**Overview:** Production error in version 1.0 harnesses; The immobilizer wire (orange/black) is in pin position #4 instead of pin position #5. Although an effort to correct the issue was made, some quantity of harnesses did get shipped before the issue was spotted. We are advising to inspect the harness BLADE connector before attempting to install harness or program the module. This issue is not known to affect the version 2 harnesses, which require no modification.

**Overview:** Early versions of the FTI-STP1 harness require modification for **automatic transmission (AT)** applications, some of the product was able to be modified before release, but a small quantity was released without modification.

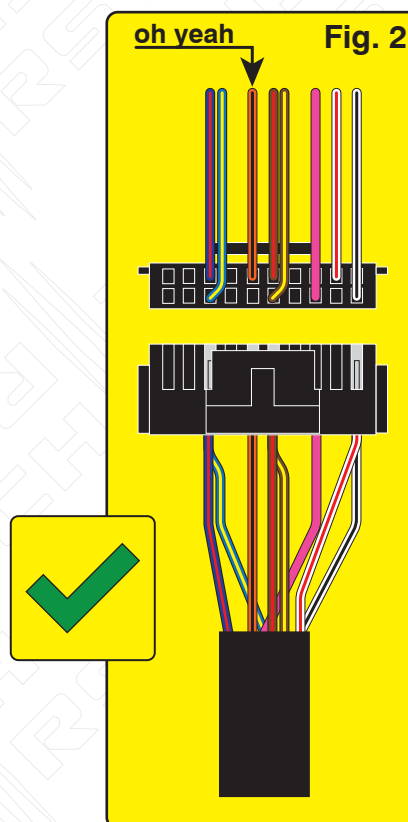
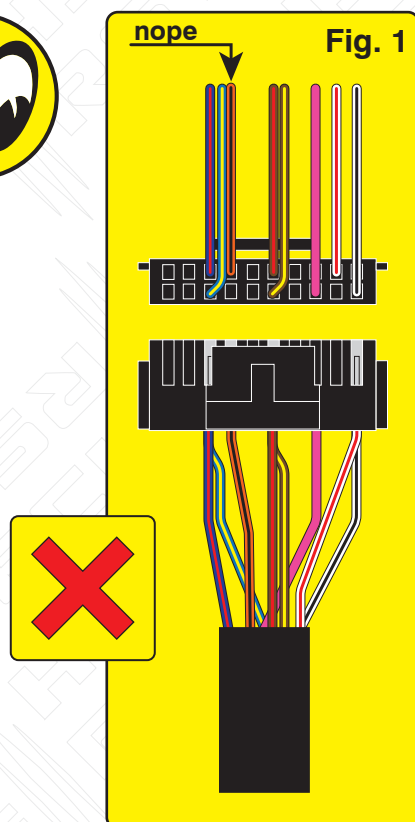
**Correction:** Step 1.) Locate the orange/black wire and confirm whether it is positioned as illustrated in Fig. 1 or Fig. 2. If the wire is as illustrated in Fig.1, proceed with Step 2 through 5 and complete the repair procedure outlined, if the wire is as illustrated in Fig. 2, correction is not necessary, proceed with harness installation and module programming.

**Step 2.)** Using a pick, lightly depress the catch that secures the terminal in the housing then remove the wire and terminal from the housing.

**Step 3.)** Using a fine tip razor or utility knife, insert the blade beneath the terminal catch and raise it slightly, so that it can be reused to secure the terminal when reinserted into the BLADE connector housing.

**Step 4.)** Refer to Fig. 2 for correct position of the orange/black wire (next to brown/red) then reinsert the terminal, pressing lightly until the catch 'snaps' into place, securing the terminal in the connector housing.

**Step 5.)** The repair is complete, proceed with installation and programming.

## MODIFICATION REQUIRED FOR A/T APPLICATIONS, ONLY WITH v 1.0 HARNESS

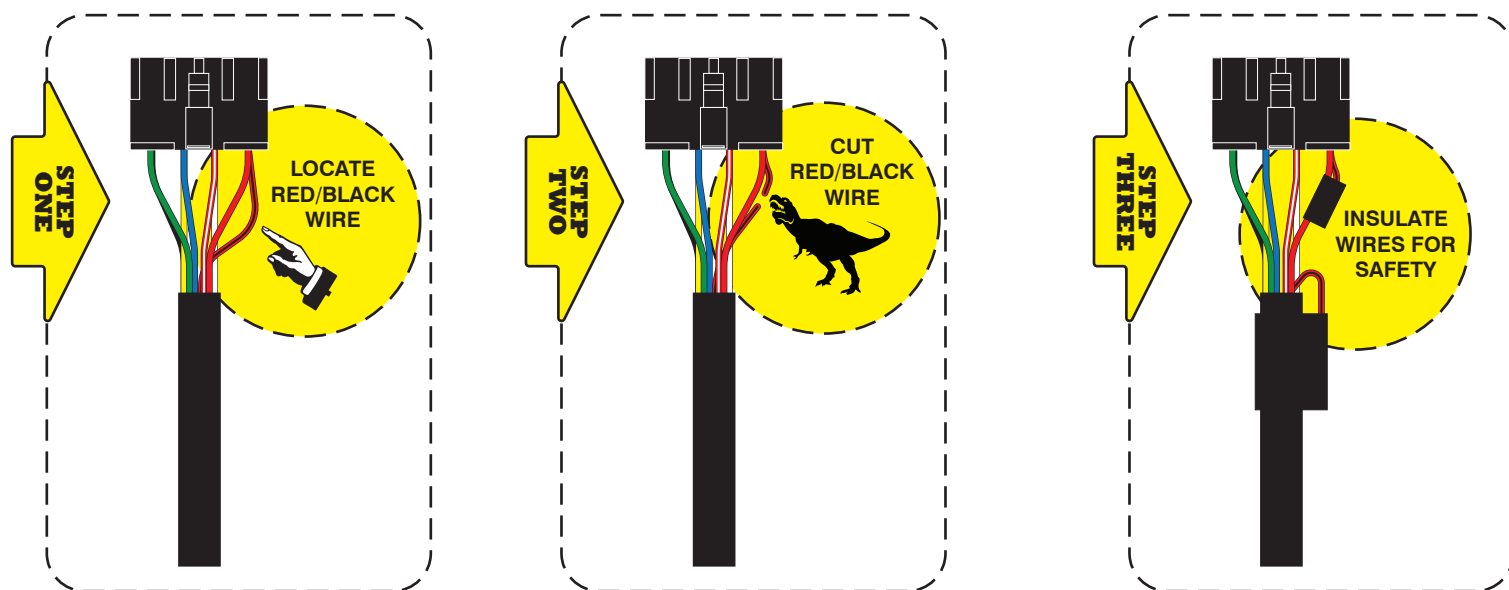
**Issue:** The FTI-STP1 T-harness has been designed to be compatible with A/T (automatic transmission) & M/T (manual transmission) applications, but due to an oversight in early production runs, the selection was defaulted to M/T mode.

Using a harness configured for an M/T application, in an A/T equipped vehicle, could result in vehicle module damage, it is advised that the harness be returned to A/T mode before installation in vehicles equipped with an automatic transmission.

**Correction:** Locate the **red/black** (+ Clutch) wire provided in the CN1 connector of the main harness assembly. Cut the **red/black** wire, either flush to the CN1 connector, or leaving enough wire exposed so that you can insulate and secure the ends of the wire that remain after cutting. Insulate each of the remaining ends of the **red/black** wire and secure to prevent any possibility of a short circuit. **If the red/black wire has already been disconnected, no further modification is required for A/T applications**
